**Committee of Experts on the Transport of Dangerous Goods
and on the Globally Harmonized System of Classification
and Labelling of Chemicals**

**Explosives and related matters: Review of
Chapter 2.1 of the GHS**

Review of Chapter 2.1 of the GHS

**Submitted by the Australian Explosives Industry and Safety Group Inc.
(AEISG)**

Figure 2.1.1: Overall scheme of the procedure for classifying a substance, mixture or article in the class of explosives (~~Class 1 for transport~~)

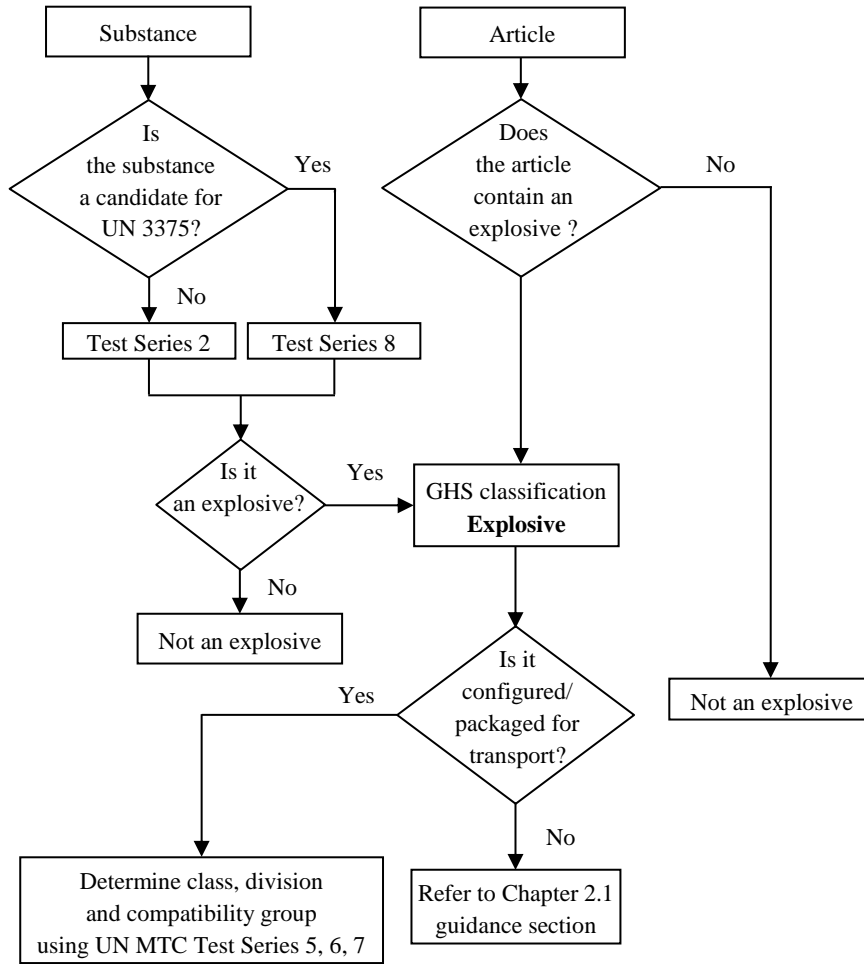
The classification of substances, mixtures and articles in the class of explosives and further allocation to a division is a very complex, three step procedure. Reference to Part I of the *UN Recommendations on the Transport of Dangerous Goods, Manual of Tests and Criteria*, is necessary. The first step is to ascertain whether the substance or mixture has explosive ~~properties~~ effects (Test Series 2 ~~4~~). This step may be avoided if the substance or mixture has been manufactured with a view to producing a practical explosive or pyrotechnic effect. The second step is to continue the acceptance procedure (Test Series ~~3 and 4~~ ~~2 to 4~~) and the third step is the assignment to a hazard division (Test Series 5 to 7). The assessment whether a candidate for “ammonium nitrate emulsion or suspension or gel, intermediate for blasting explosives (ANE)” is insensitive enough for inclusion as an oxidizing liquid (Chapter 2.13) or an oxidizing solid (Chapter 2.14) is answered by Test Series 8 tests. The classification procedure is shown in ~~according to the following decision logics (see Figures 2.1.1 to 2.1.4).~~

[Editorial Note: It is proposed that all the existing figures 2.1.1 – 2.1.4 are to be deleted and replaced with the following.]
